*** SUITE 511 * (INVENTORY SUITE)**

SUITES 511 - NOYAC BAY (Inventory Suite)

Royal Pine Homes 25 Baker Hill Blvd - Stouffville, ON Apr 04, 2018

SUITE 511
ORIGINAL LAYOUT
INVENTORY SUITE
NEXT LAYOUT

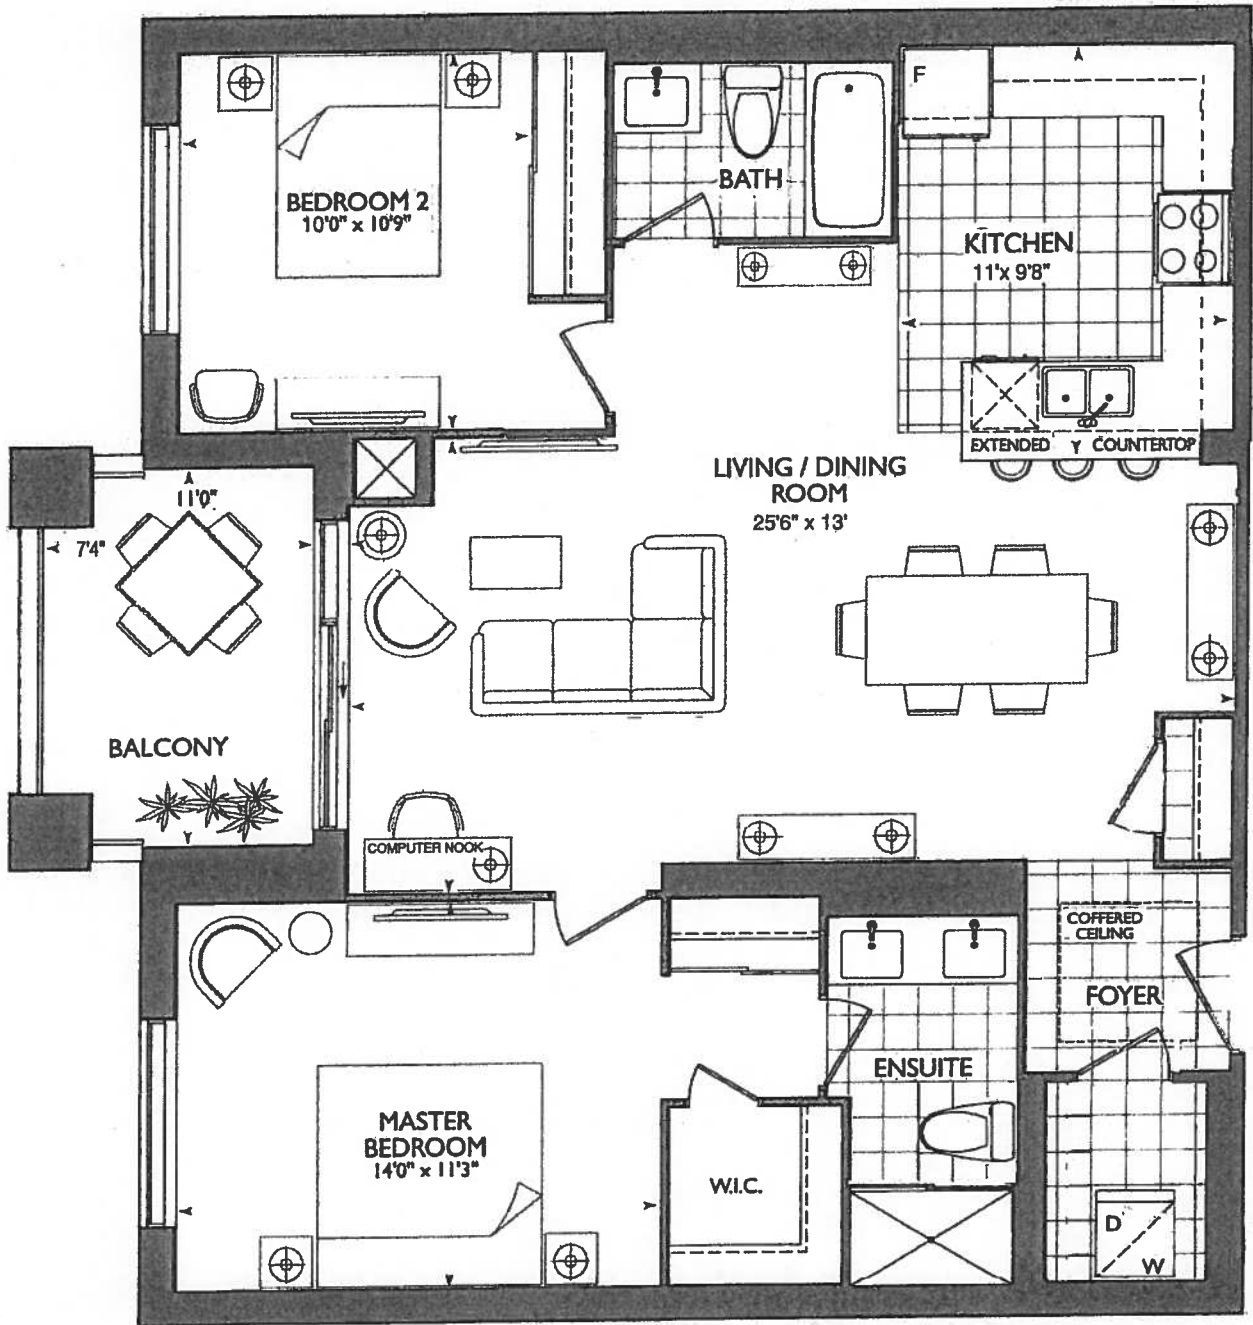
- NEW TUB
- REMOVED DEN
- REVISED KITCHEN

***REVISED LAUNDRY DOOR SWING &
ENSUITE WALL AS PER THIS BROCHURE**

**#1- KITCHEN LAYOUT WITH 1ST UPG.
APPLIANCE PACKAGE**

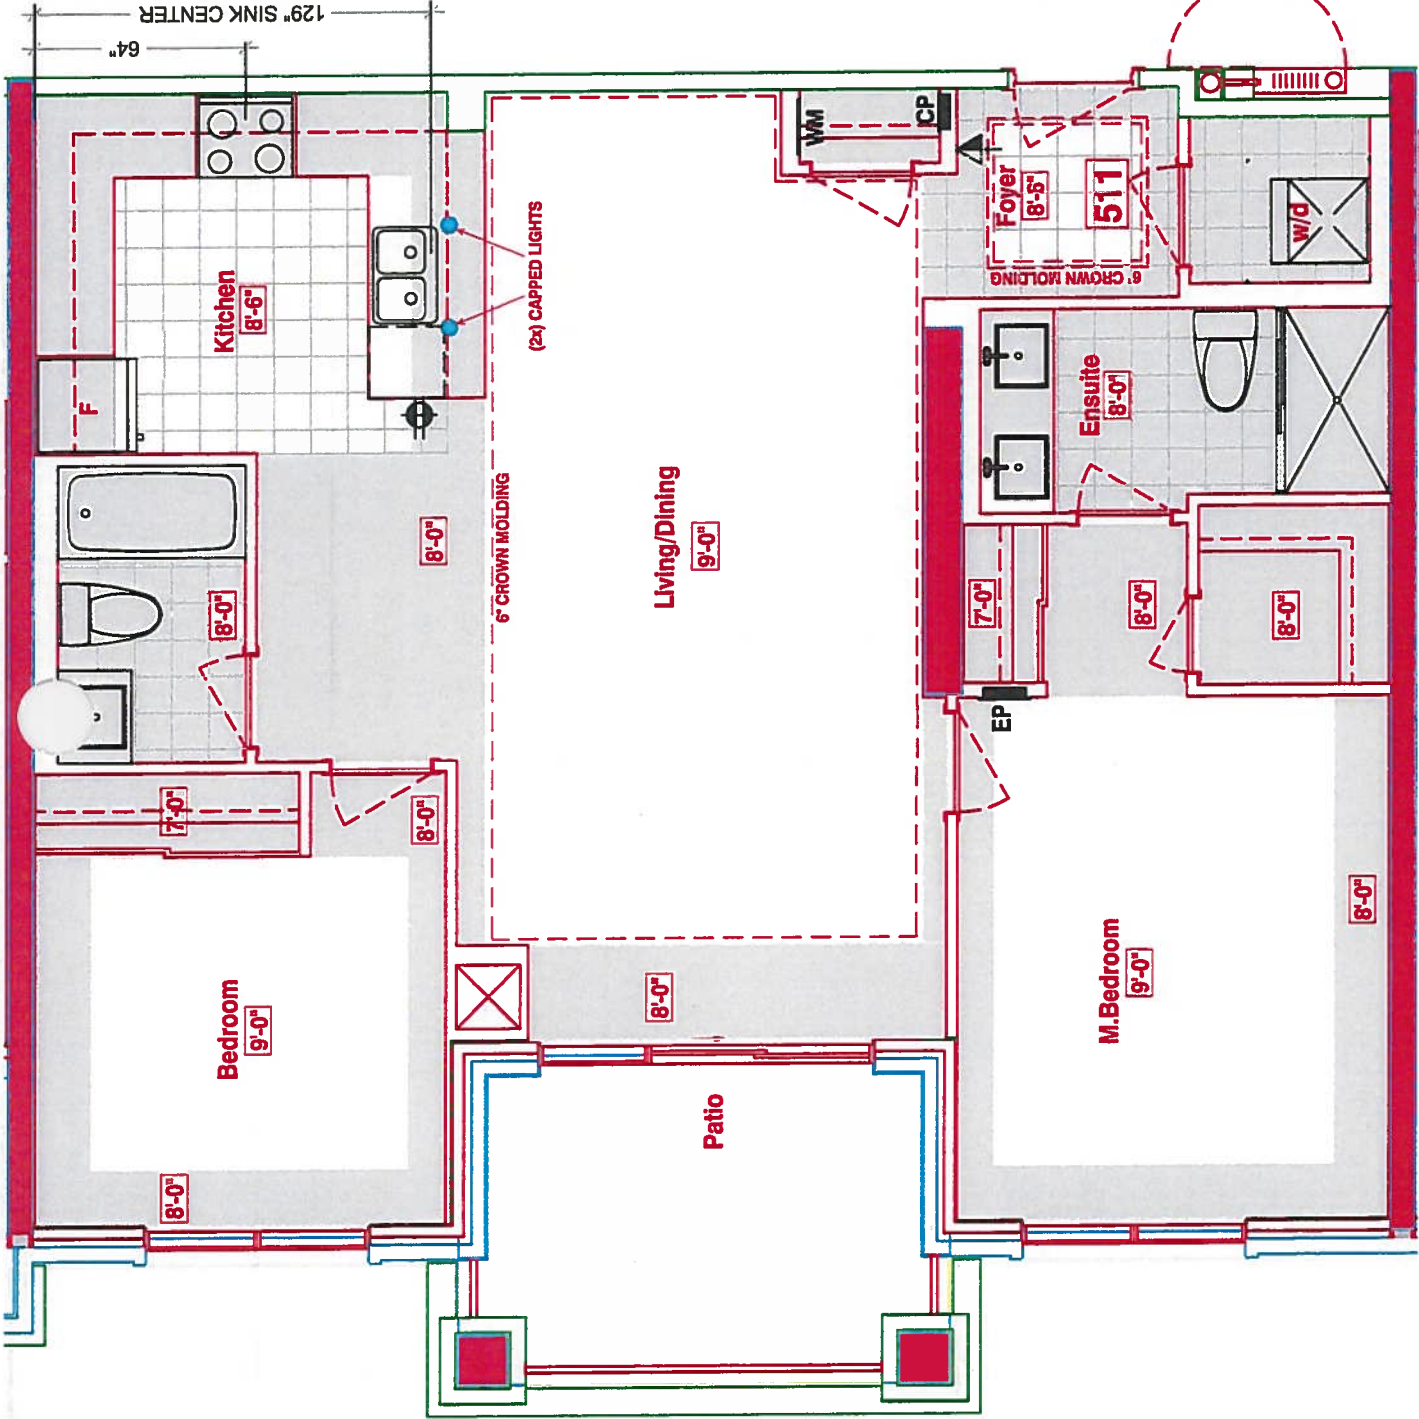
- (x2) CAPPED PENDANT
- (x1) PLUG PENINSULA
- (x) PUCK LIGHTS

***SEE ATTACHED UPG.**

Suite 311- INVENTORY
Suite

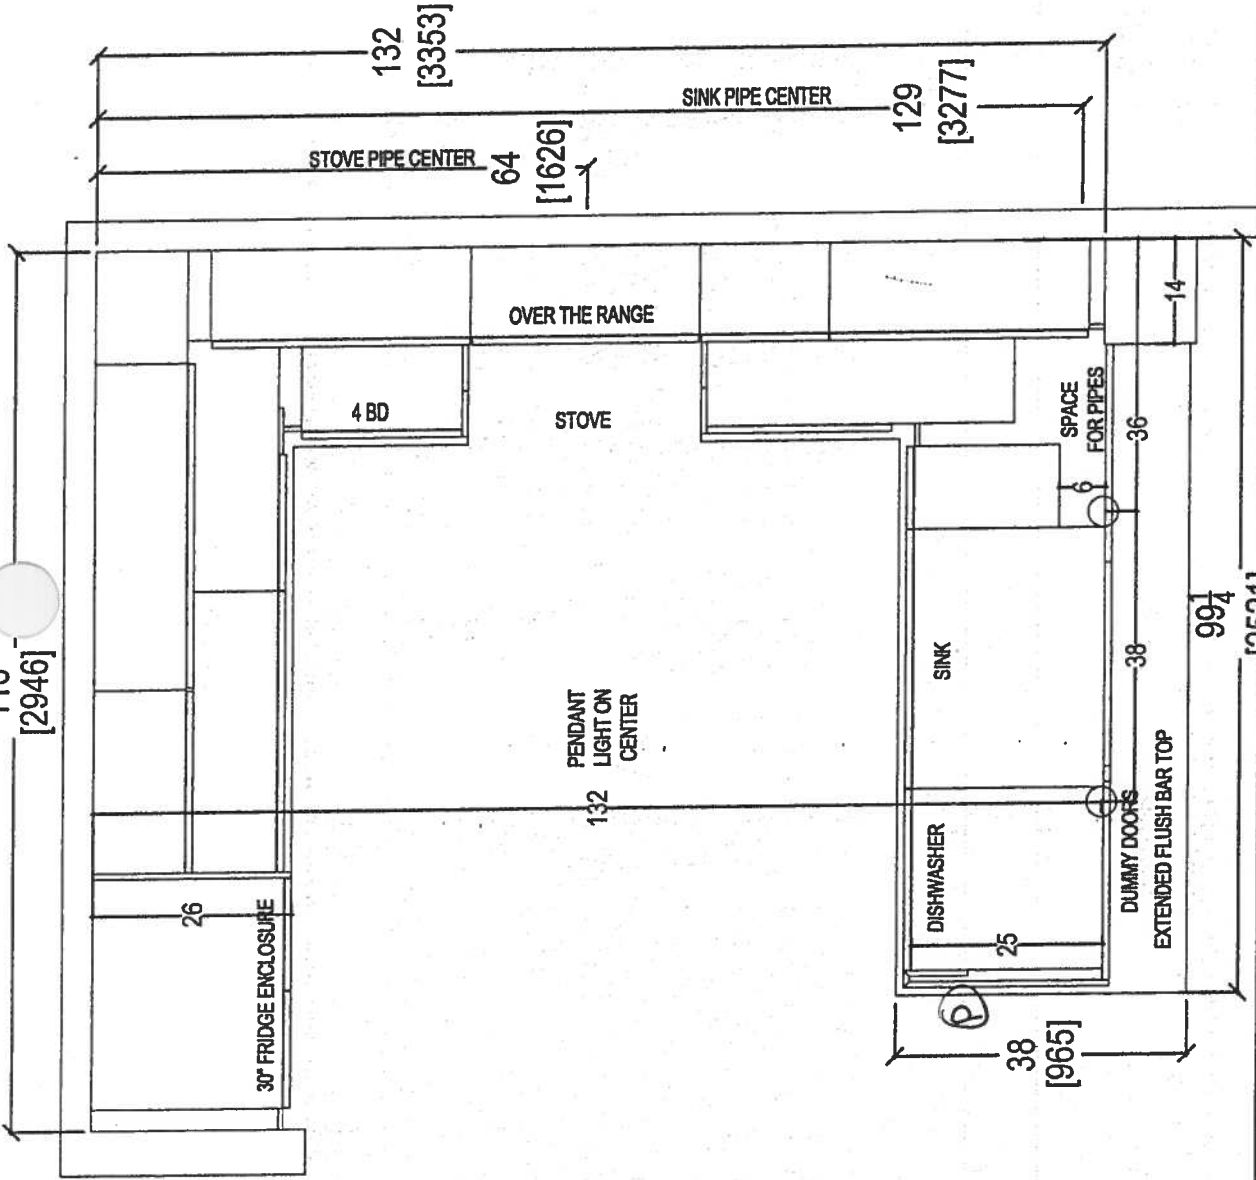
- STO KITCHEN LAYOUT
- STO APPLIANCE PACKAGE
- (x1) = PLUG PENINSULA
- (x2) = CAPPED PENDANT LIGHTS
- (x5) = PUCK LIGHTS

SUITE 511 INVENTORY
SUITE

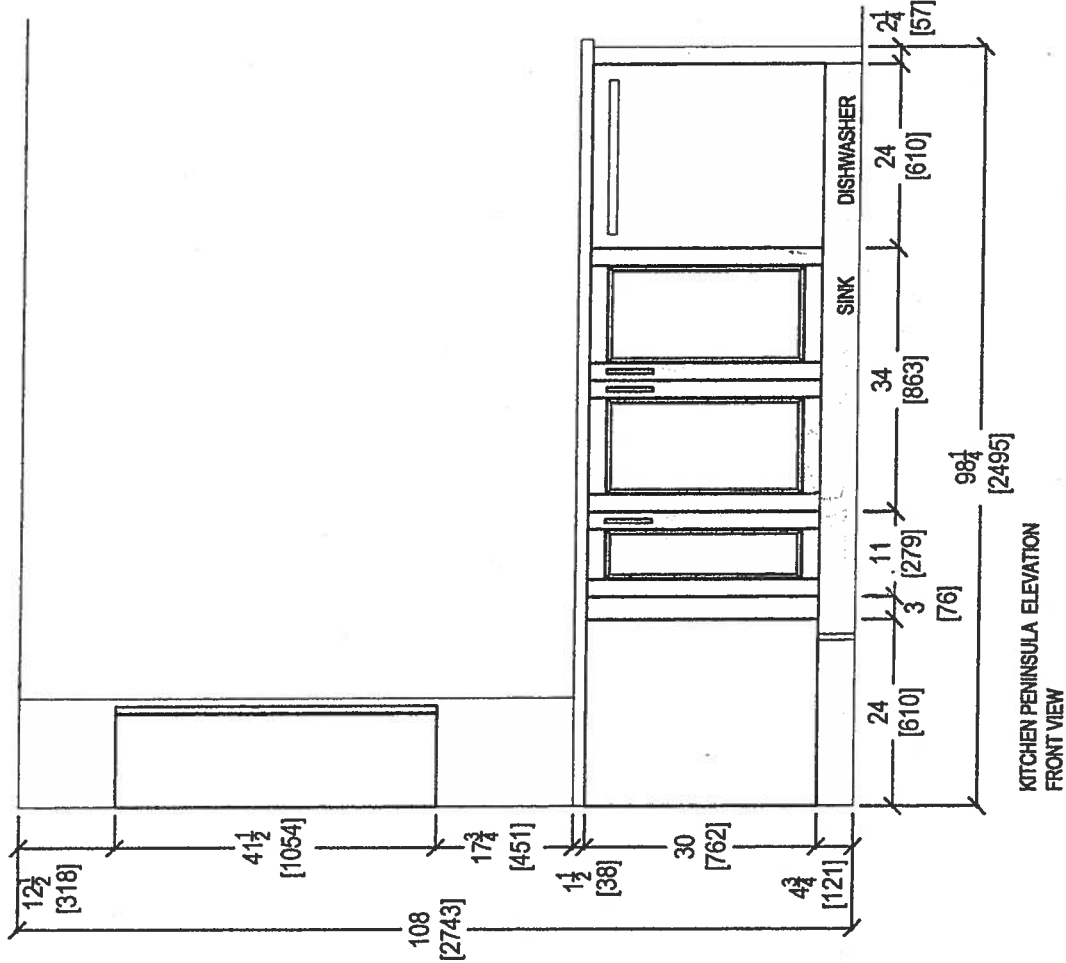
- OPTIONAL = 1ST UPGRADE
KITCHEN LAYOUT
- OPT. 1ST UPG APPLIANCE
PACKAGE
- (x1) = PLUG PENINSULA
- (x2) = CAPPED PENDANT
LIGHTS
- (x7) = PUCK LIGHTS
